NUCLEAR ENERGY INSTITUTE

March 11, 2003

NEI 99-03
Revision 1

Control Room Habitability Guidance

Figure 1 CRH Program

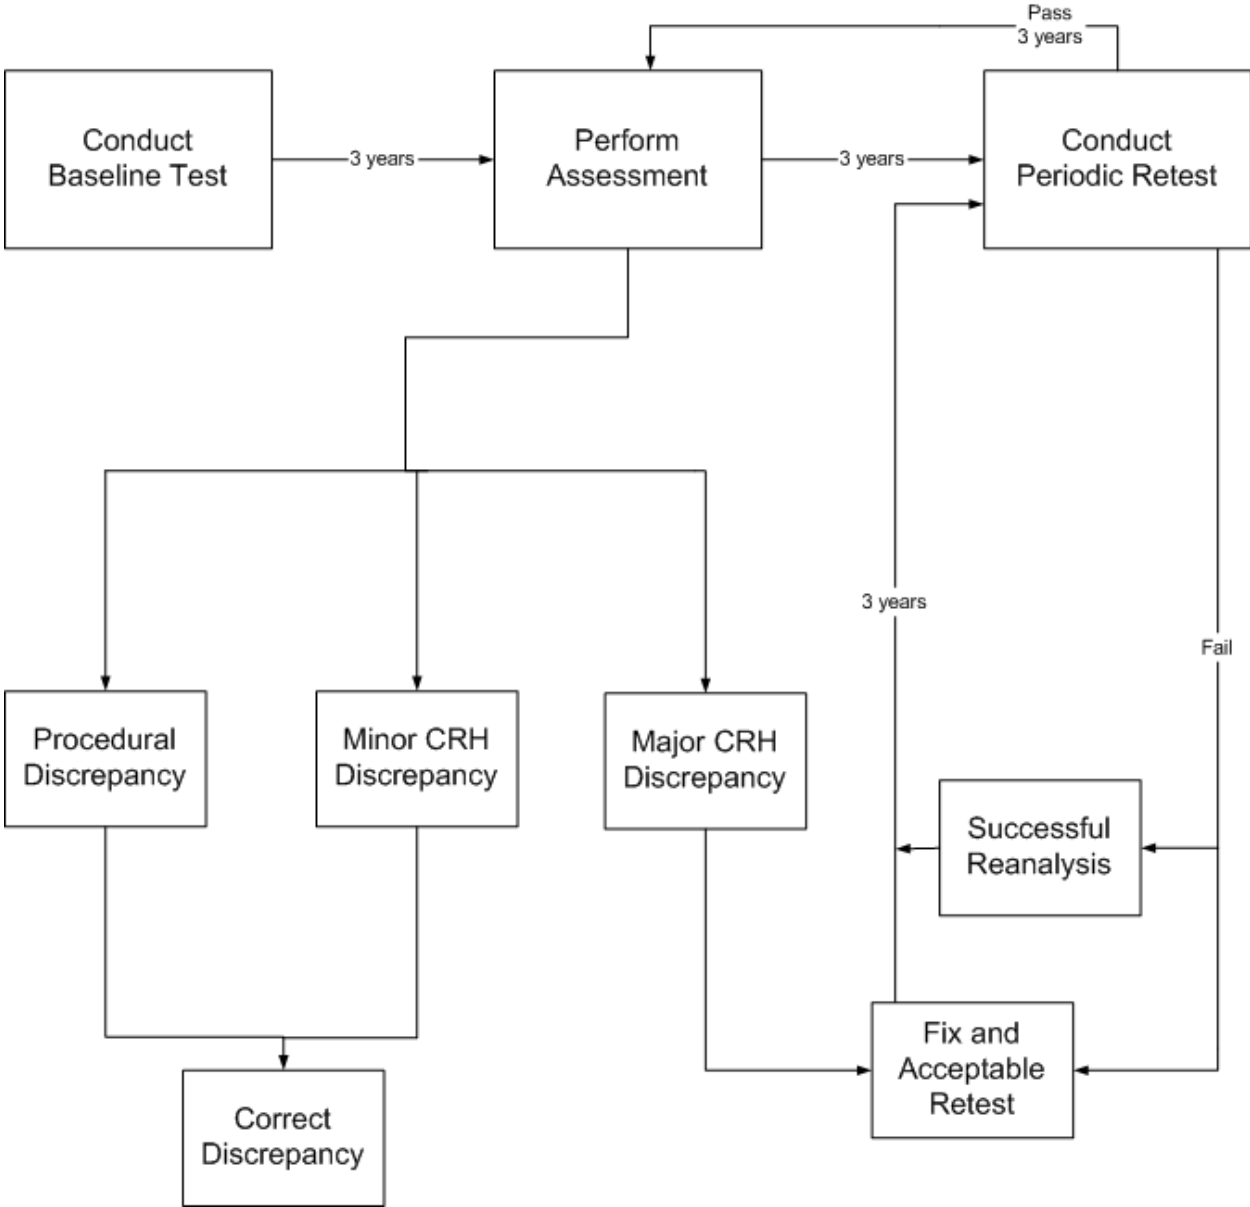
CMT #	PARA. OR SECTION	NRC COMMENT	NEI DISPOSITION	ACTION TAKEN
27.	Figure 1 and §4.3.1 through 4.3.3	<p>Figure 1 does not reflect the corresponding staff figure discussed at the workshops. As a consequence of expanding the logic for corrective actions flowing out of an assessment, the industry used the completion of the corrective actions that result from an assessment as the starting point for the three-year clock. This is reflected in the text (e.g., in §4.3.1, “. . . three years following completion of the Section 4.2 baseline test AND any corrective actions . . .”). The staff’s position is that the time interval is to be taken as three years following the last successful performance of the action, whether it is a baseline test, assessment, or periodic test. Predicating the timing of the next action on the completion of a corrective action could forestall the next action for as long as it takes the item to work its way up the corrective action priority list. This is unacceptable.</p>	<p>It is inappropriate for the 3-year frequency to begin with the completion of corrective actions for minor deficiencies (without the need for retesting). The guidance states that 3-year frequency is to begin with the completion of the most recent assessment or retest.</p> <p>Figure 1 will be redrawn to delete the arrow from the “Correct Deficiency” box to the arrow exiting the periodic retest’s “fix and retest” box.</p> <p>Figure 1 will be redrawn to show the line originating from the two “fix and retest” boxes and the “reanalyze” box to go directly into the “periodic retest” box, with the “(3 years)” note added to this redrawn line.</p> <p>Section 4.3.1 will be revised to reflect these changes.</p>	<p>Implemented,</p> <p>Figure 1 has been revised and simplified to represent the common intentions of the industry and the NRC.</p>

34.	Figure 1	This figure is different from that presented by the staff. Figure 1 does not provide a failure path for the retest following a repair or if re-analysis cannot relax the acceptance criteria. The staff expects that following a failed periodic retest, efforts to fix and retest will continue in a timely manner until a successful test is performed. The three-year interval to the next periodic retest starts upon obtaining a successful retest result.	Addressed in Resolution to Comment 27.	Implemented, Revised Figure 1
